CITY OF ALBUQUERQUE

**RE: Lot 3 Block 3 Unit 22 SAD 228
6536 Papagayo NW
Volcano Cliffs Subdivision
Grading and Drainage Plan
Engineers Stamp Date; 7/25/18 (D10D003I17)
Pad Certification Date; 10/4/18**

ENGINEER'S SEAL	Title 6536 PAPAGAYO NW	DRAWN BY
		DATE
7/25/18 Richard Dourte P.E. #10854	GRADING AND DRAINAGE PLAN	Day
	<i>RHD Engineering, LLC</i> 4305 Purple Sage Ave. NW ALBUQUERQUE, NM 87120 (505) 288-1621	SHEET # 1 of 1 JOB #

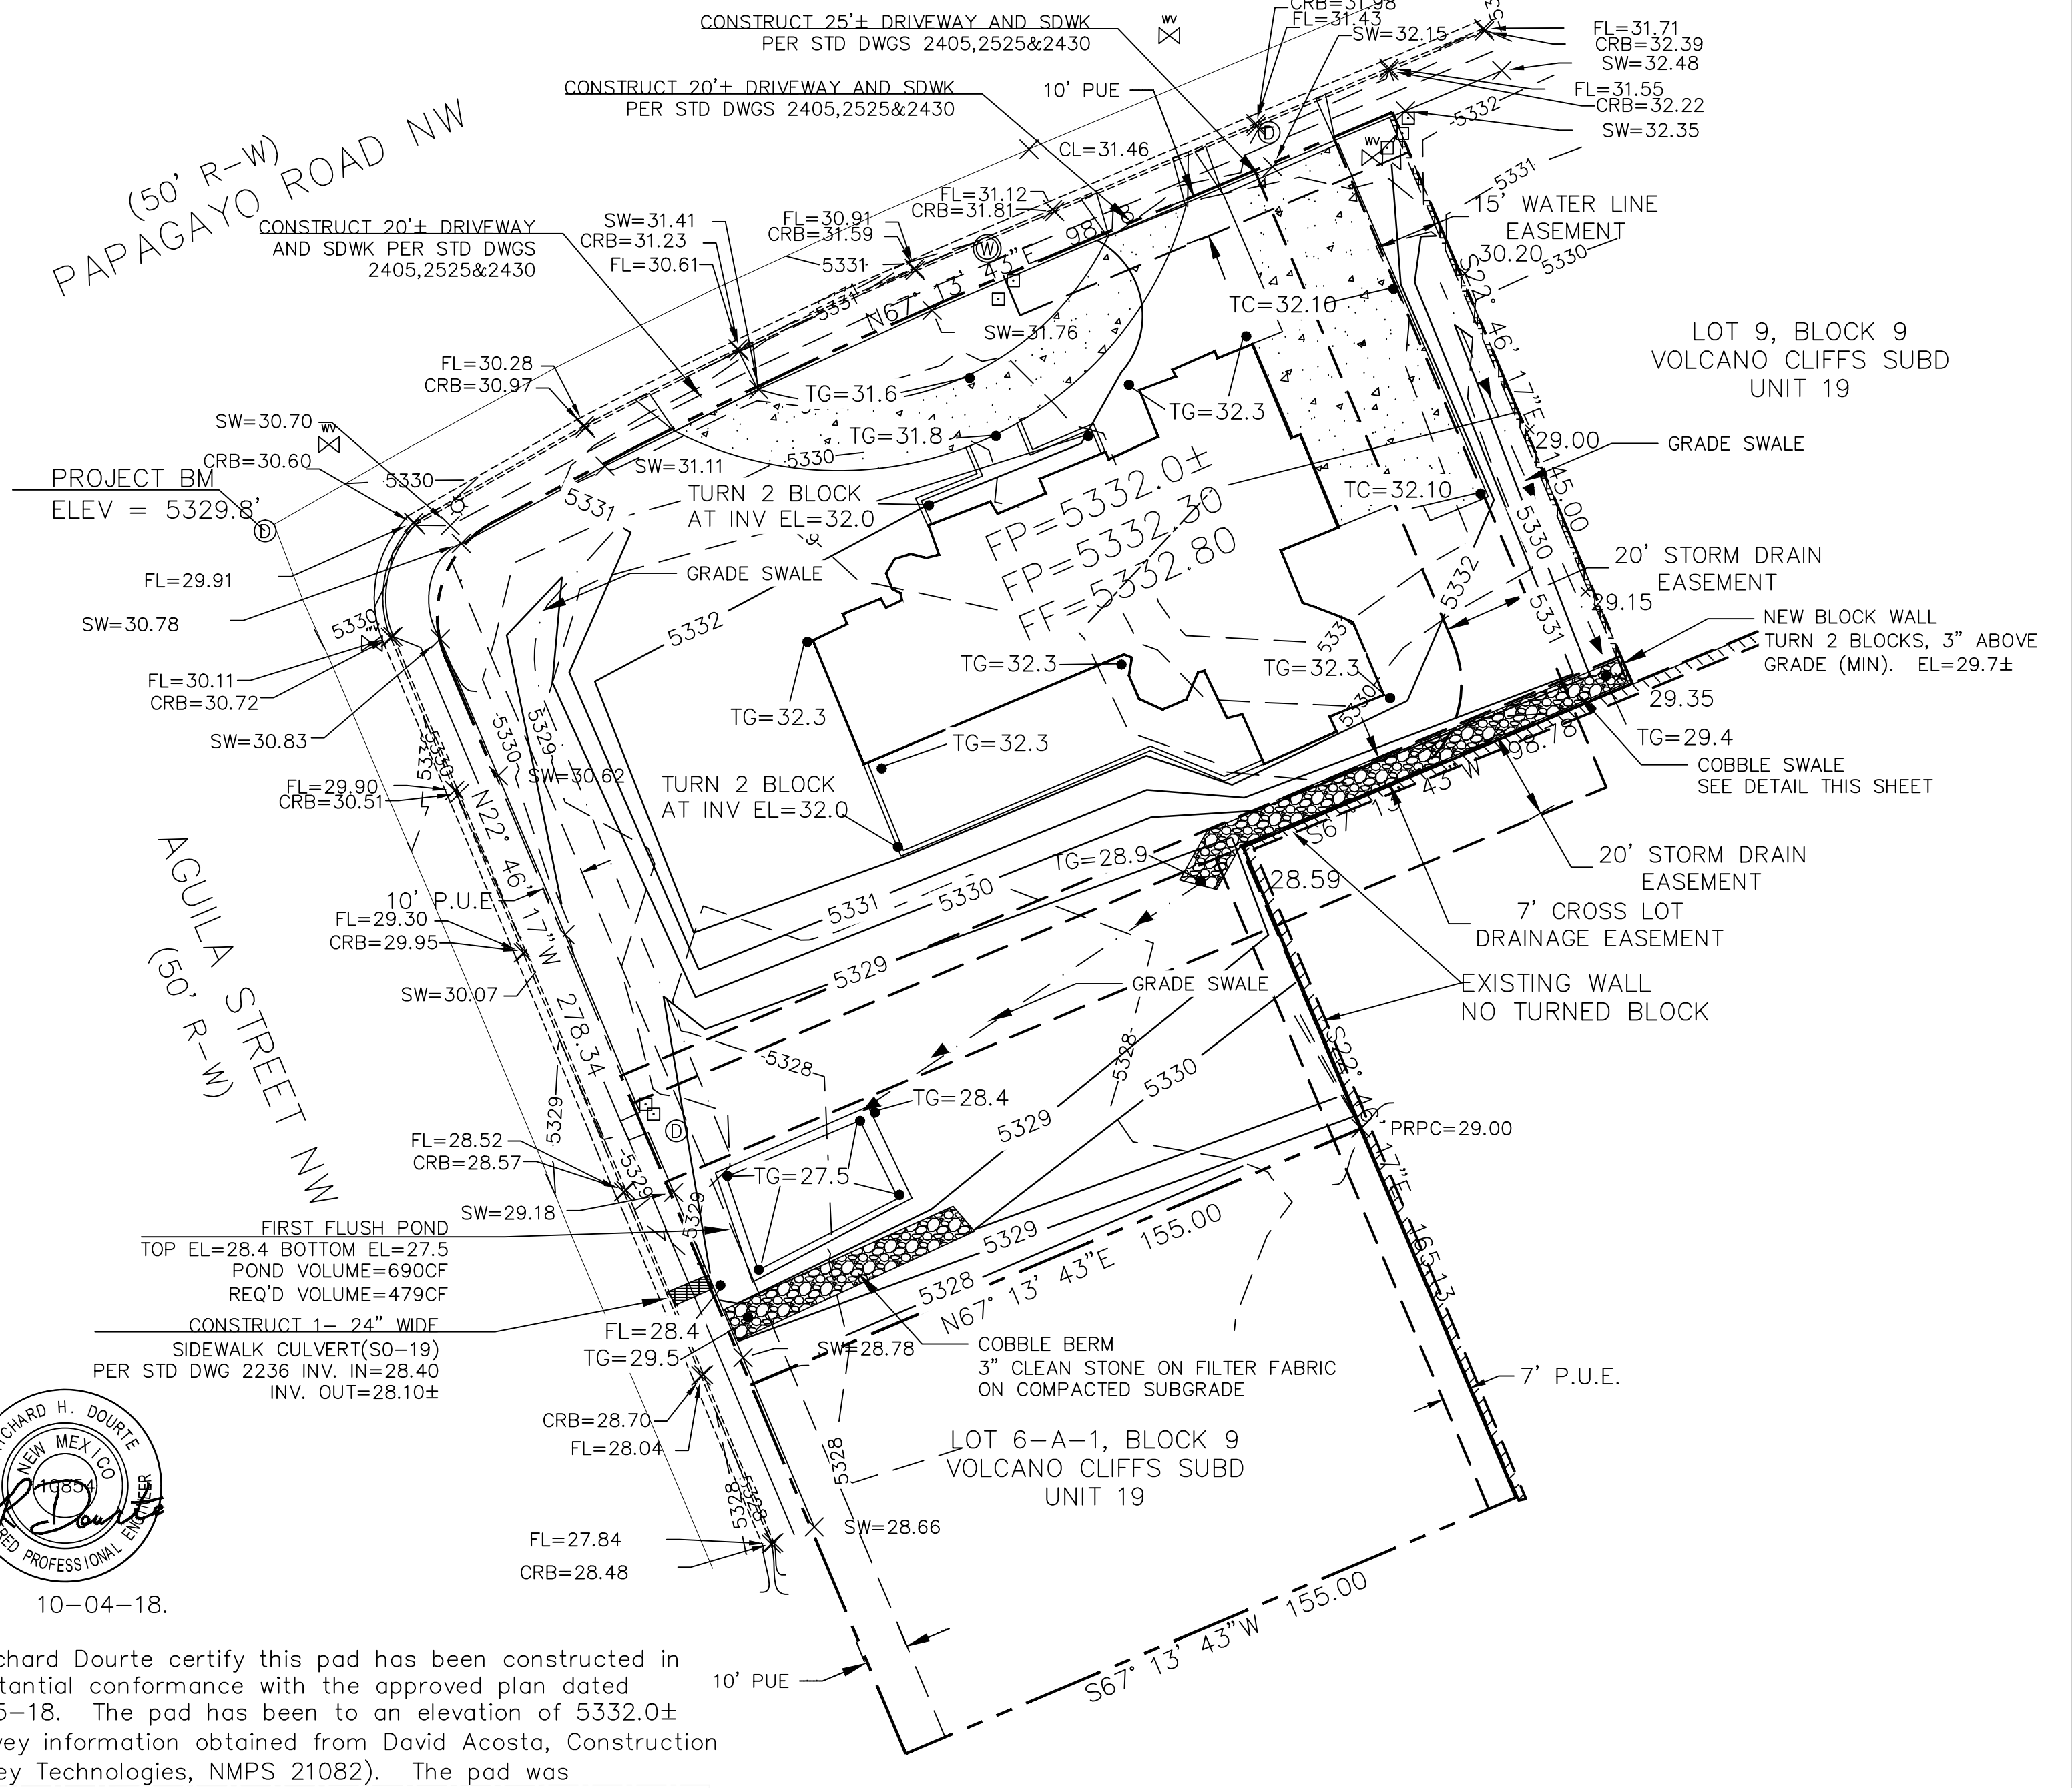
- Remove the dirt from the street and the public sidewalk. Explain to the contractor that dirt curb ramps are not allowed in the street. Use lumber, gravel or a pavement base for this ramping.
